FIGURE 6.2-1
MANAGEMENT ORGANIZATION CHART
CALVERT CLIFFS NUCLEAR POWER PLANT
BALTIMORE GAS & ELECTRIC COMPANY

CALVERT CLIFFS UNIT 1

FCR 82-06
Supp. 1

FCR 84-34

FIGURE 5.2-1
MANAGEMENT ORGANIZATION CHART RELATING TO
ENVIRONMENTAL MATTERS
CALVERT CLIFFS NUCLEAR POWER PLANT
BALTIMORE GAS & ELECTRIC COMPANY

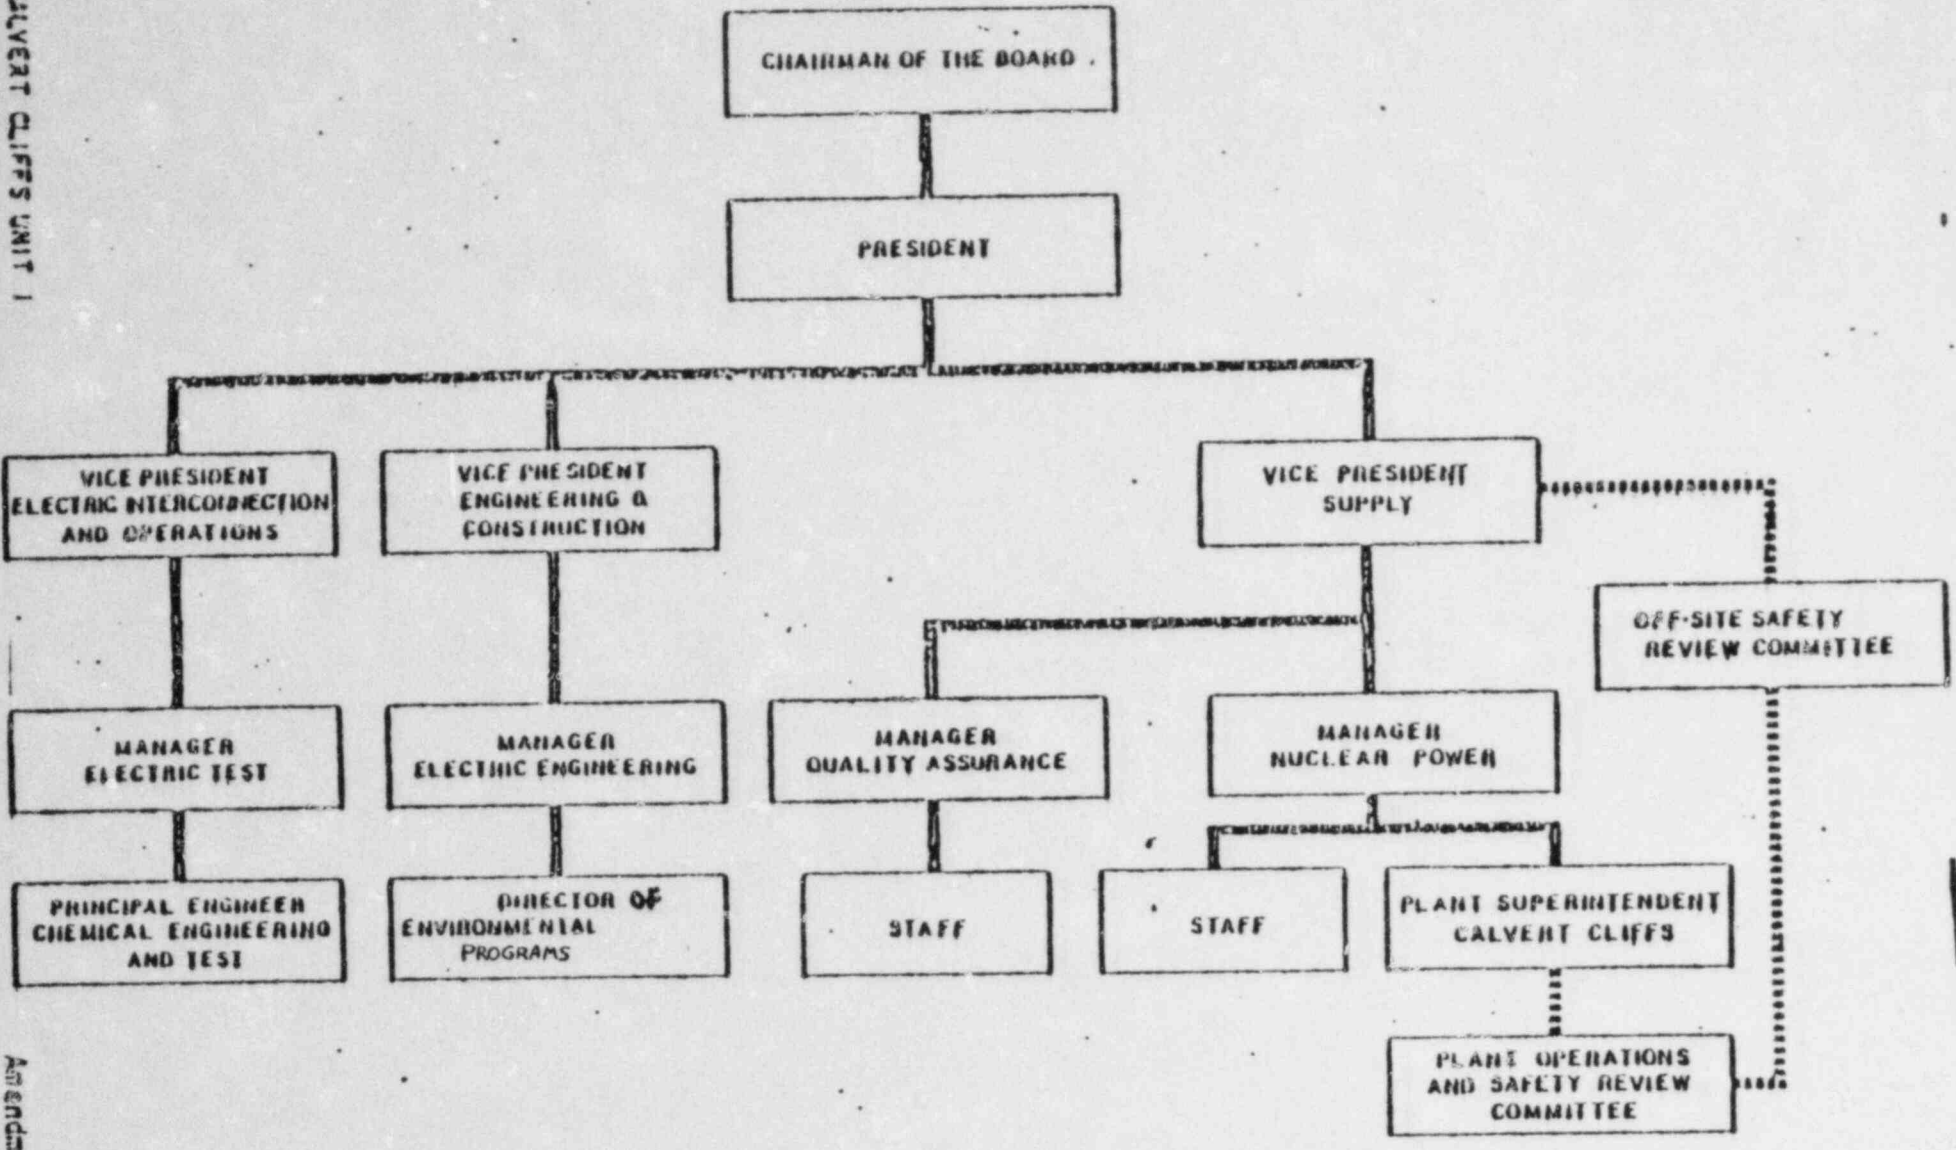
^{Director of Environmental Programs,}
The ~~Chief Environmental Engineer~~, Electric Engineering Department, has the direct responsibility to assure compliance with the specifications presented in Sections 3.0 and 4.0.

Environmental Programs Unit,
The ~~Environmental Engineering Group~~, Electric Engineering Department shall be responsible for:

All written operating procedures and changes thereto, which pertain to specifications in Sections 3.0 and 4.0, shall be reviewed by the Environmental ~~Engineering~~ ^{Programs} Unit ~~Group~~, Electric Engineering Department and approved by the ~~Chief Environmental Engineer~~ ^{Director of Environmental Programs} prior to implementation, except as provided below:

Temporary changes to operating procedures which do not change the intent of the original procedure may be made provided such changes are approved by the project leader as specified in the operating procedure. Such changes shall be subsequently reviewed by the Environmental ~~Engineering Group~~ ^{Programs Unit} and approved by the ~~Chief Environmental Engineer~~ ^{Director of Environmental Programs}.
